TECHNCIAL NOTE no.: 47	
Product:	ADU Software upgrade
Part number:	
To:	Cupra Leon Competición & Audi RS3 LMS
Date:	11/05/2023

New Software versions for the ADU (Advanced Display Unit) from ECUMaster have been released to solve some bugs that were reported.

-  with Delta time
-  without Delta time

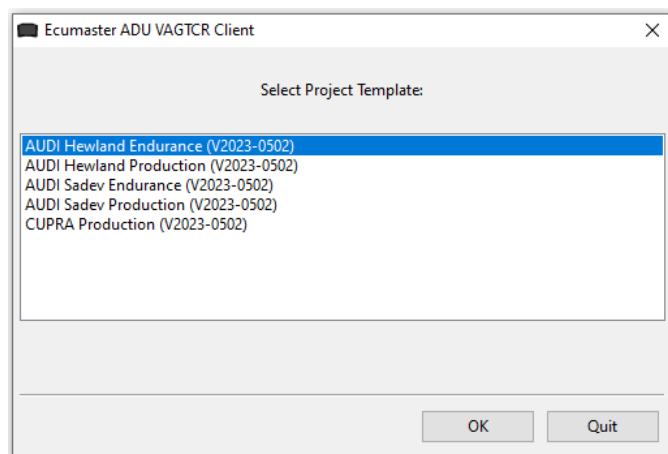
Note that in the portal you will find two folders with the difference that one folder contains project templates without "predictive lap time" layout and the other does. The reason is that although "predictive lap time" is prohibited in the 2023 TCR regulations, there are some championships with a waiver. Choose the one that corresponds to yours.

New cars are delivered without "predictive lap time" project template.

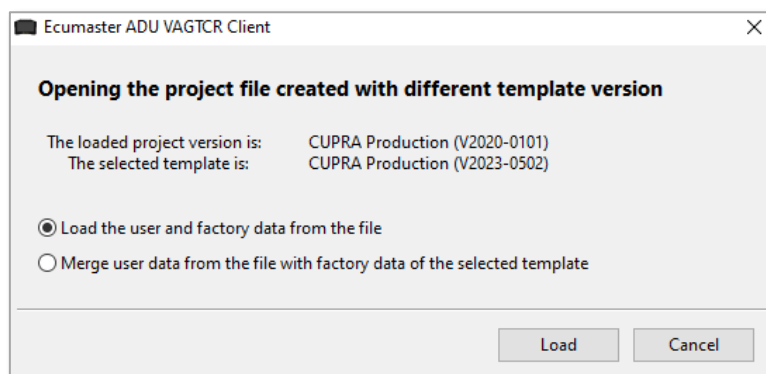
After installing the new version of this software, in the opening process of the program, the customer must select the desired template to work with. There will be several templates already loaded to help the customers to work with them, before connecting with the car. It is important to load the proper template according to the brand name, gearbox model or type of race, to be able to use the adequate layouts, alarms, or channels.

Once the template is open, if it is required, you will be able to modify and save it as a new project.

Once you are plugged in with the car, remember to click on **“Make Permanent”** icon or go to “File / Make Permanent” to store the project on the display.
